Attachment 1 – Roadway System Refinement Details

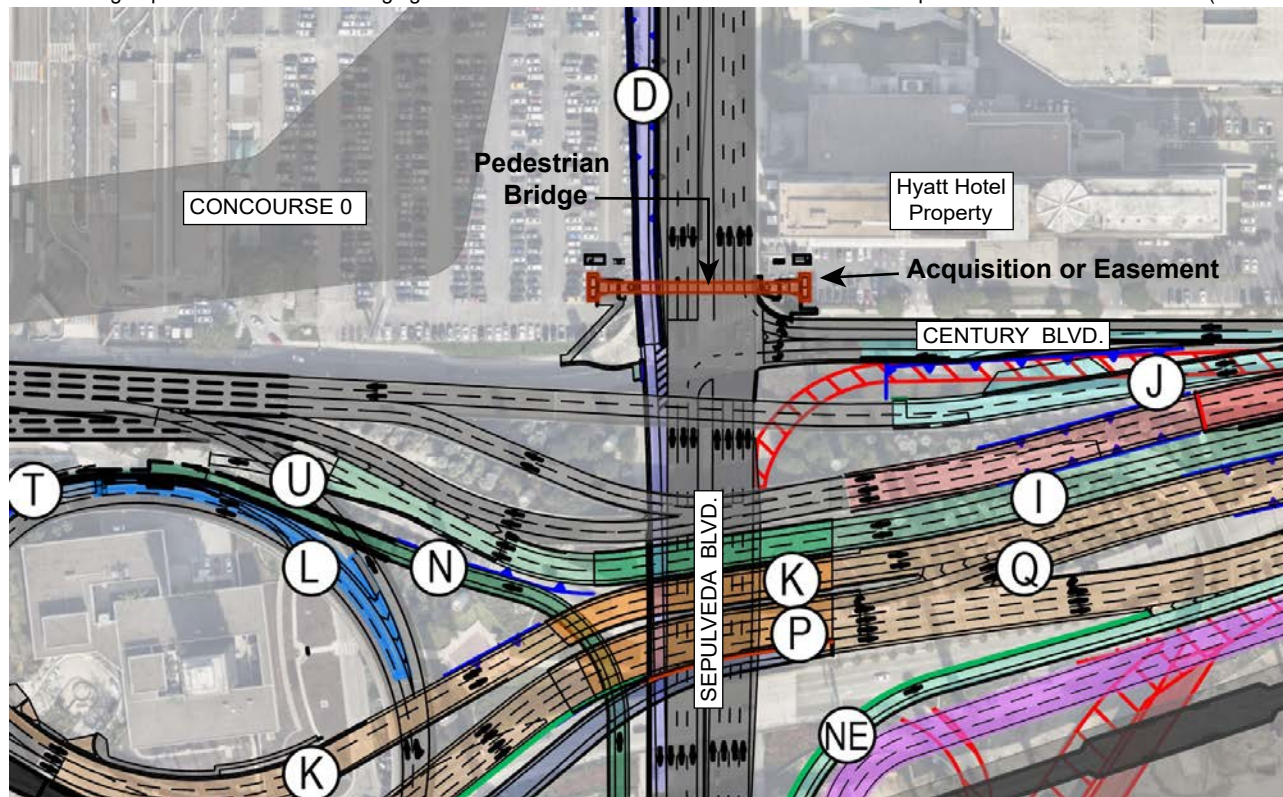
Image 11: A pedestrian bridge would be added over the northern leg of the intersection of Sepulveda Boulevard and W. Century Boulevard. An acquisition or easement would be required on the Hyatt Hotel property for construction of the pedestrian bridge.

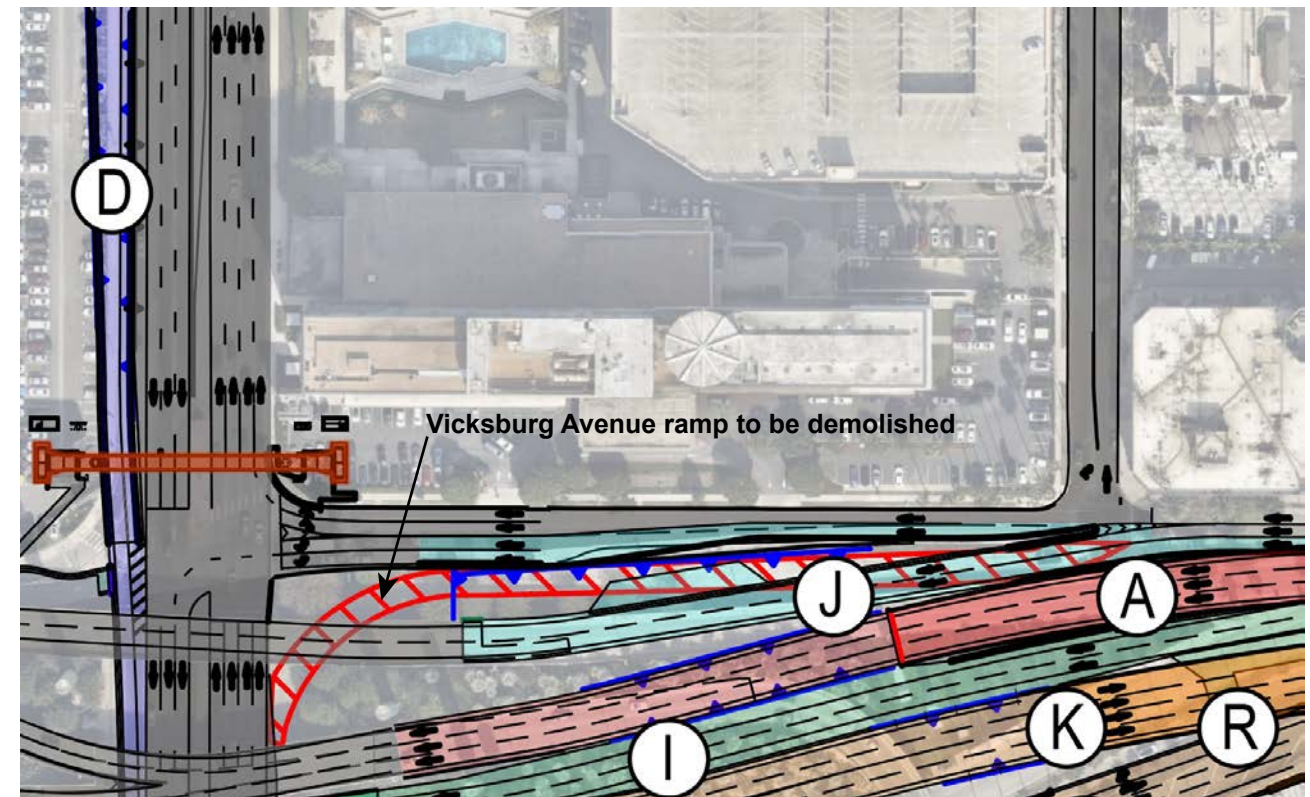
Image 12: Vicksburg Avenue from Sepulveda Boulevard northbound would be demolished.

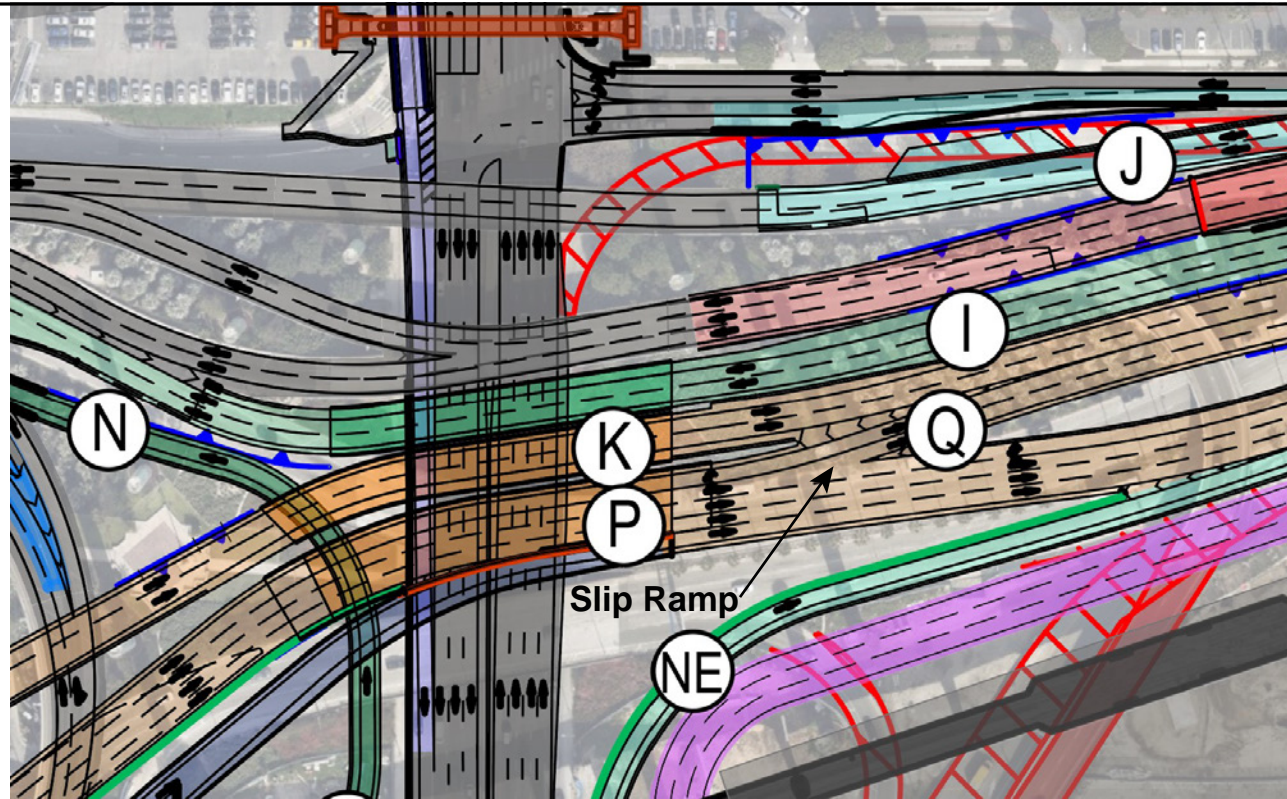
Image 13: Instead of a weaving section between Segments K and P, a slip ramp would be added between Segments K and P and the weaving section would be removed.

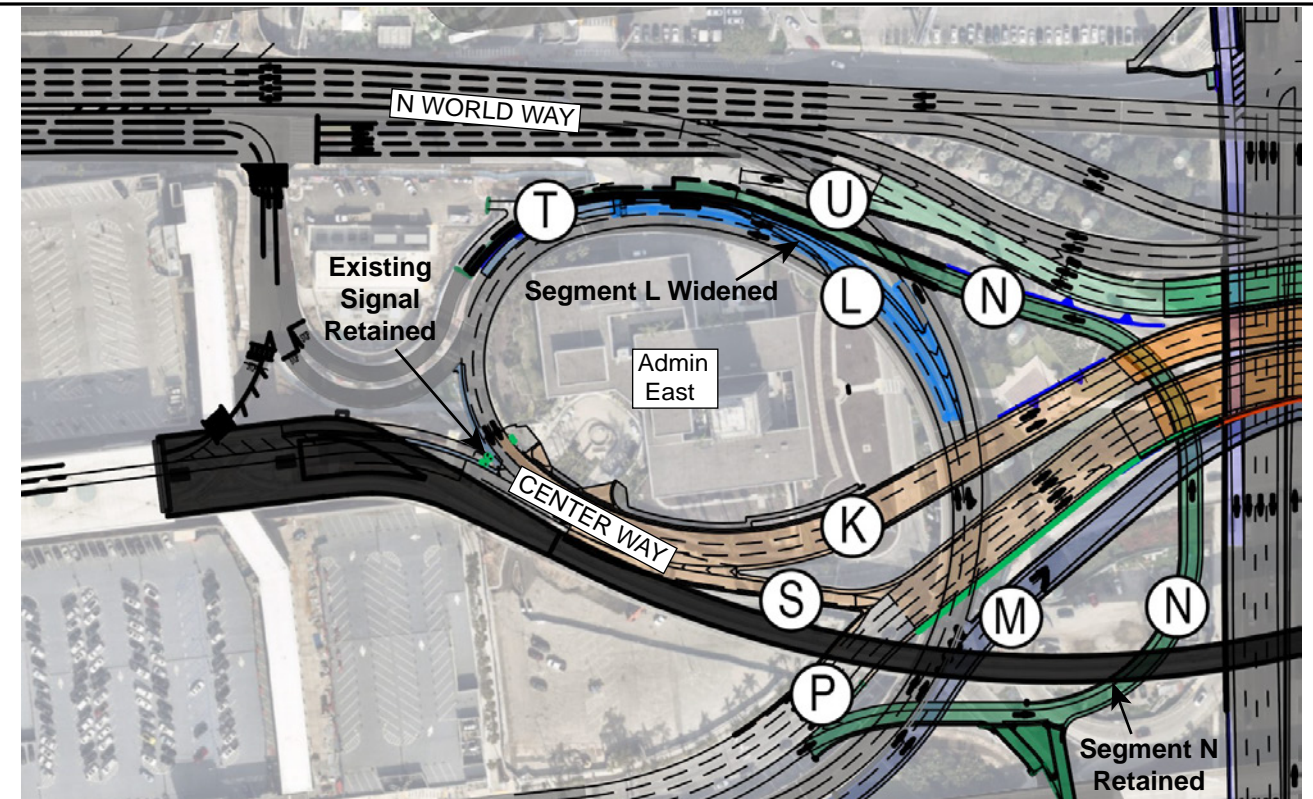
Image 14: Instead of full replacement as contemplated in the Final EIR, the existing loop ramp bridge, designated Segment L, would be widened. Existing signal would be retained at Center Way for pedestrian access at Admin East. Instead of reconfiguring the airport return, the existing airport return, designated Segment N, would be retained.

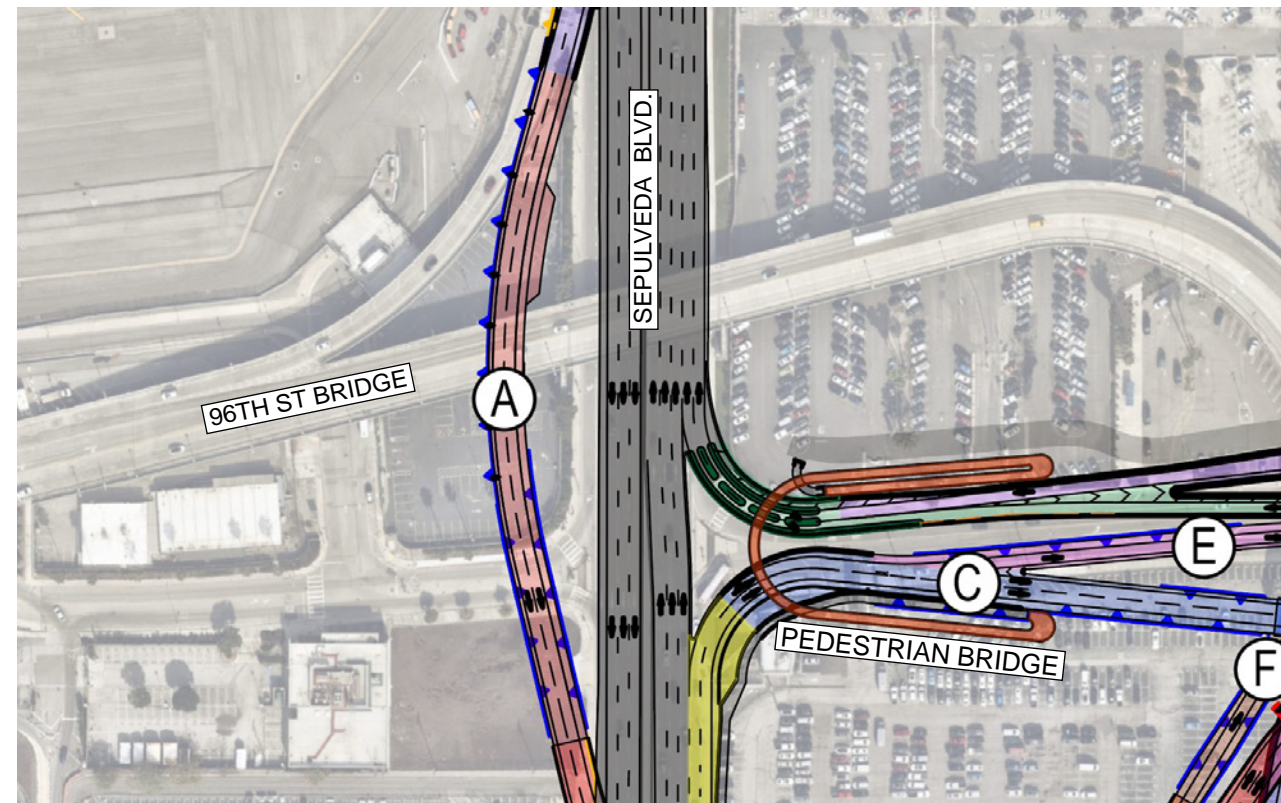
Image 15: The offramp from Sepulveda Boulevard southbound, designated as Segment A, would be realigned so that it would not conflict with existing support columns under the 96th Street Bridge.
